ITEM	4
MANAGER'S REPORT #	35
COUNCIL MEETING	95/07/24

SUBJECT: **PROPOSED FILLING OF A PORTION OF BURRARD INLET FOR COMMUTER RAIL**

PURPOSE: To provide Council with information regarding an application to the Vancouver Port Corporation to fill a portion of the Burrard Inlet foreshore for the commuter rail project.

FIGURE 1

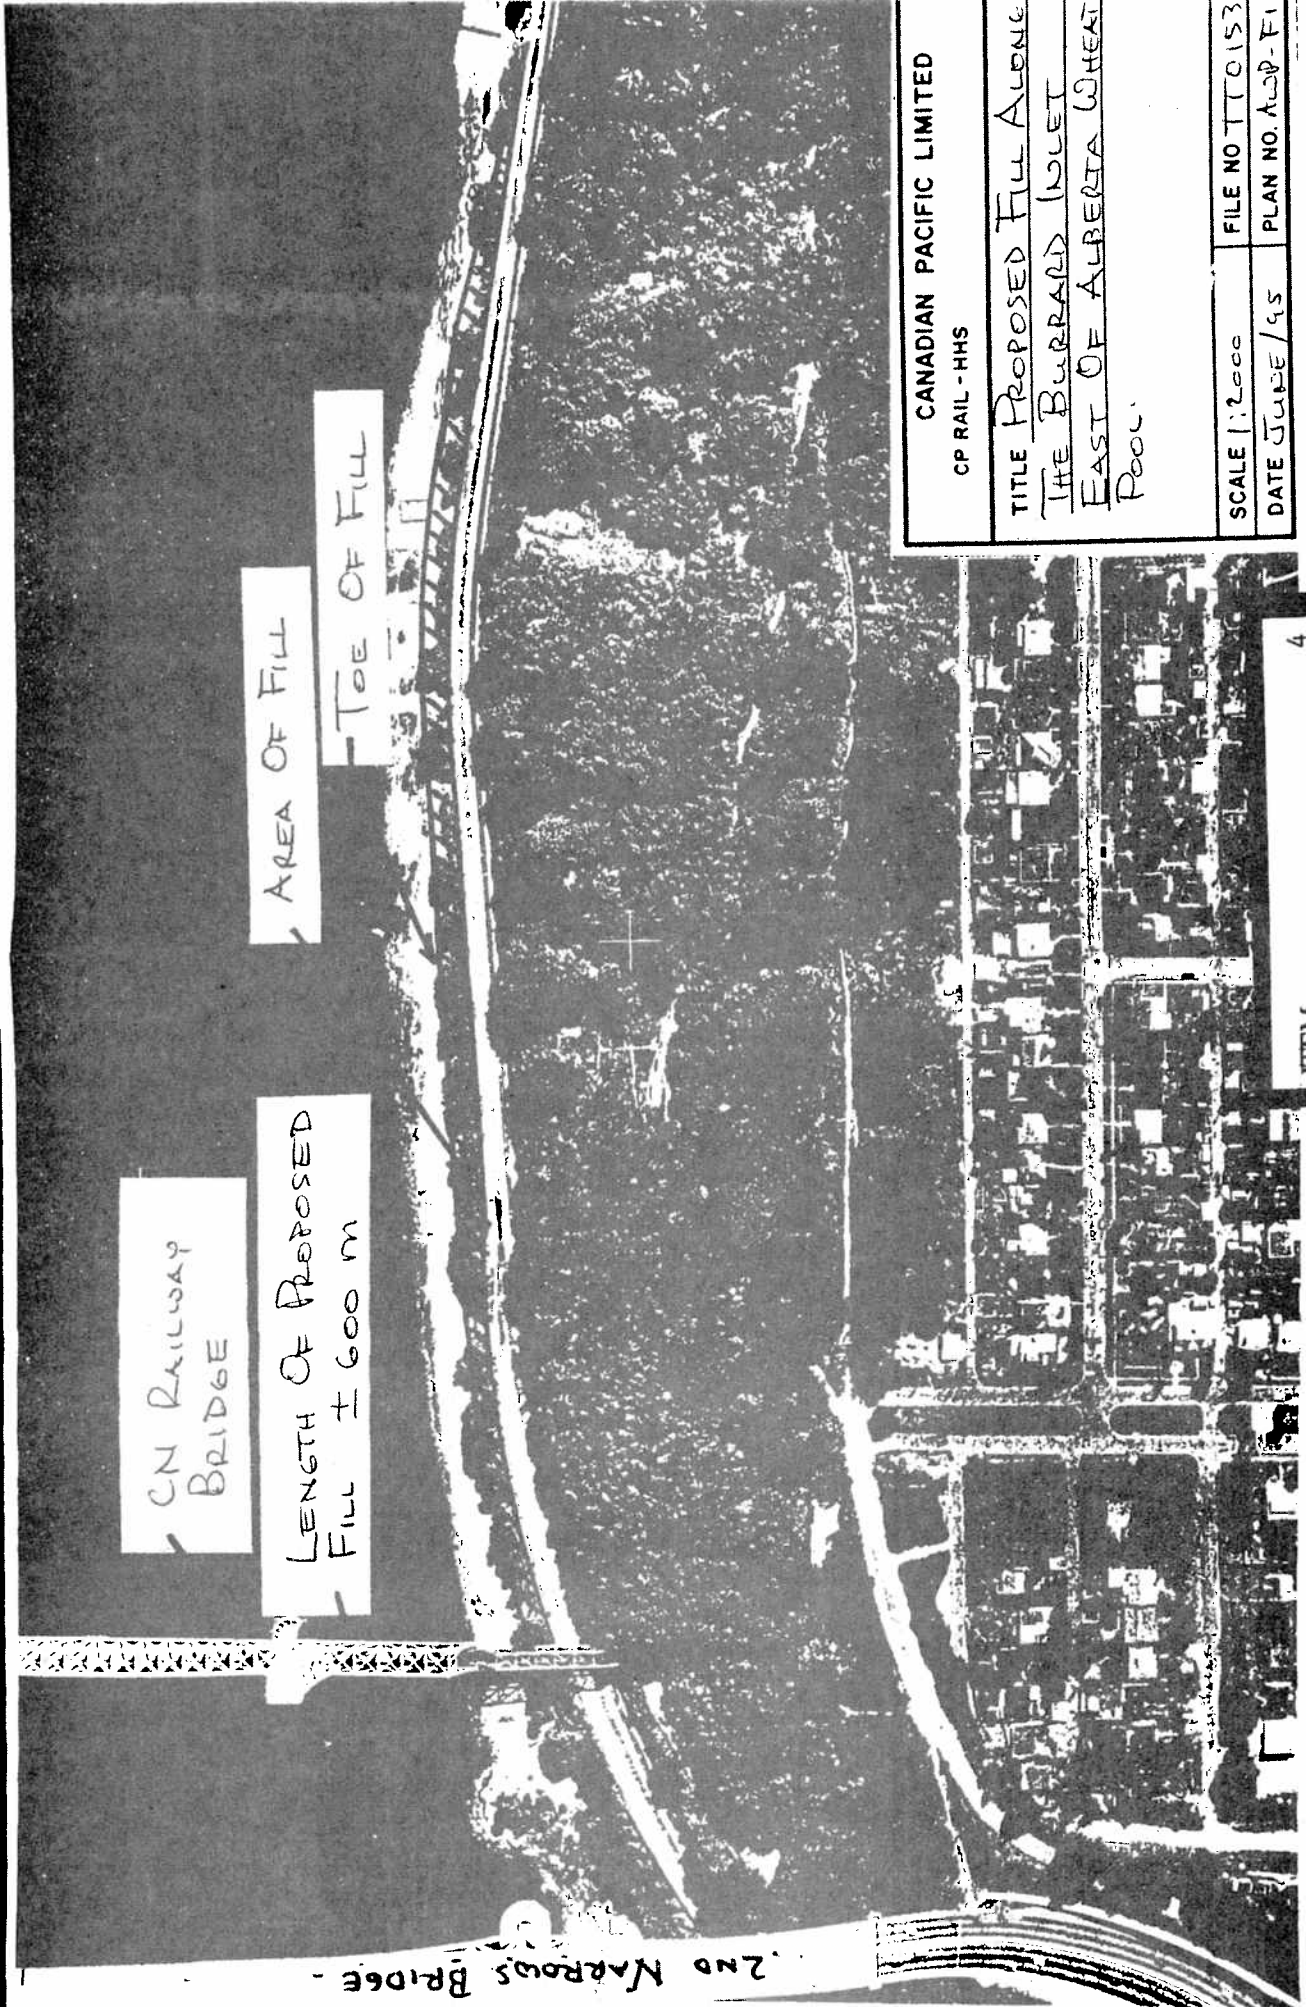
CP Rail proposes to place approximately 600 metres of fill along the shore, extending eastward from the Second Narrows road and rail bridges as illustrated on Figures 1 and 2 **attached**. The fill and its structural containment is proposed to extend approximately 10 metres from the high water mark into the intertidal zone. Treatment along the fill is proposed to consist of either rip rap or a retaining wall as depicted on Figure 3 **attached**. An additional freight storage track is then proposed to be constructed on the fill to replace the lost storage capacity described in Section 2.0 above.

Staff recognizes the need for the proposed works as a component of the construction of the commuter rail project and, as such, supports the proposal in principle. We do, however, believe that the environmental aspects should be adequately reviewed as intended through CEAA and BERC. It is our view that the City should be made aware of the results of this review and consulted on an ongoing basis. While we recognize that environmental mitigation measures have yet to be determined, it is our view that consideration should be given to rip rapping certain areas in such a manner as to provide intertidal benches appropriate for habitat.

It would also be beneficial if information was provided on what the potential impacts may be during construction and the measures to be employed to control sedimentation, disruption to existing bottom sediments and habitat.

Another concern is the potential for establishing long-term public access along the Burrard Inlet foreshore. The City has identified, as a long term objective, the need to establish a continuous urban trail along the Burrard Inlet foreshore as part of the adopted Urban Trail System. While the City does not have, at this time, a finite plan for the provision of public access to this portion of the inlet, staff have reviewed the theoretical implications for a pedestrian overpass in this area and/or a linear walkway along the water side of the railway. As can be seen on the Figures included with this report, the fill will only extend part way into the intertidal zone. It should be ensured that sufficient area would then potentially remain for the construction of a walkway, should this be decided to be desirable at some time in the future. Initial discussions with West Coast Express staff have indicated that the trail potential would not be precluded by the subject proposal.
